| Project | IEEE 802.16 Broadband Wireless Access Working Group < http://ieee802.org/16 > | |
| Title | FEC Alternatives for BWA Burst Communications | |
| Date Submitted | 2000-04-24 | |
| Re: | Call for Evaluations and Improvements, IEEE 802.16.1, Session #7. | |

Figure 15 – TPC performance

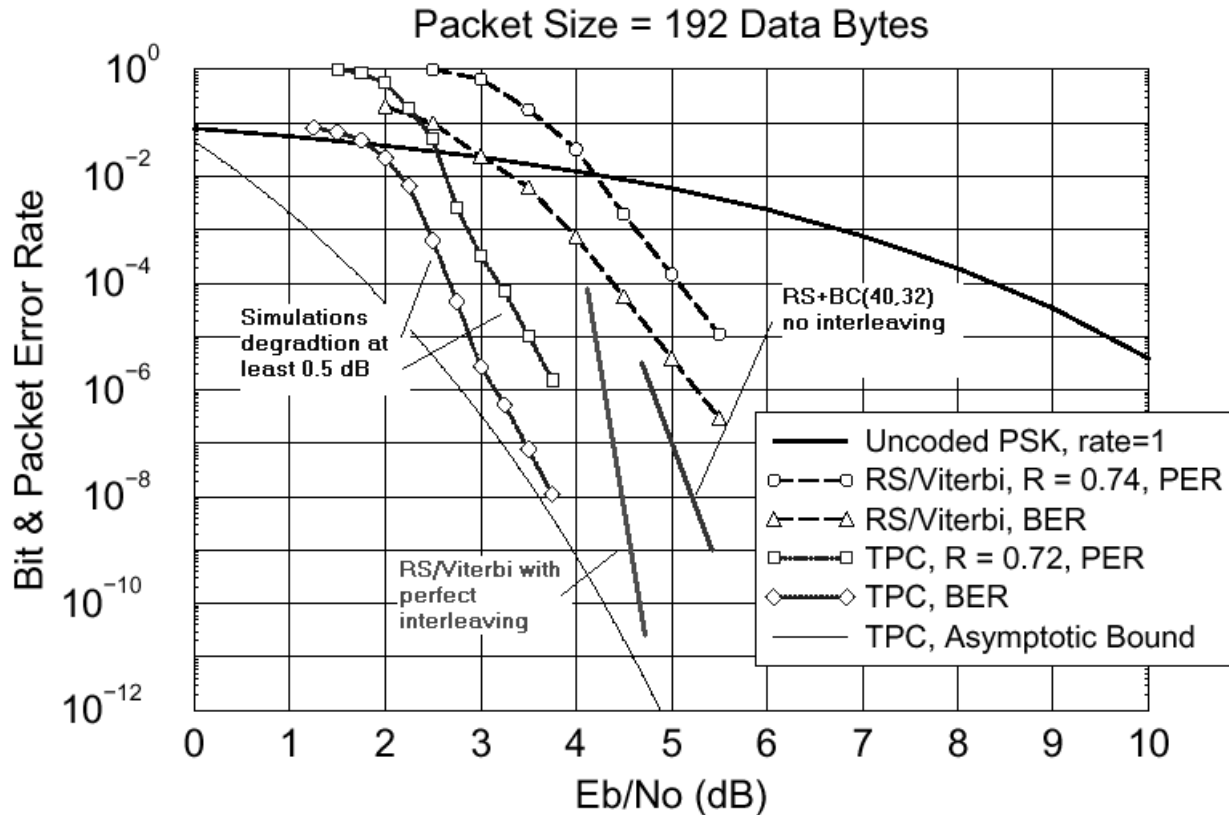
The following plot is based on an IEEE paper presented in RAWCON by AHA (<http://www.aha.com>). In the plot a concatenated RS (208,192) +Conv. Code (rate 4/5) was compared with a BTC based on a extended Hamming code (64,57) (coding rate about 0.7). The paper did an unfair comparison by assuming no interleaving for the first scheme while allowing 16 iterations for their own code. We plotted in addition to their results of the concatenated scheme with interleaving and also the code presented in sections 4,5 in this paper.

One should pay attention to the theoretical bound for the TPC code as it sets a limit on the performance (can be used to compare previous declared results). The RS+Conv. Code with perfect interleaving is only 0.5 to 1 dB worse than the TPC. The TPC results are simulations and as mentioned earlier at least 0.5 dB degradation should be expected. We also plot the case where a (40,32) code was used with RS with no interleaving, achieving practically the same coding rate with approximately the same block size. This code is practically only 1-1.5 dB worse than the TPC yet has no “burden” on hardware complexity as the TPC does.
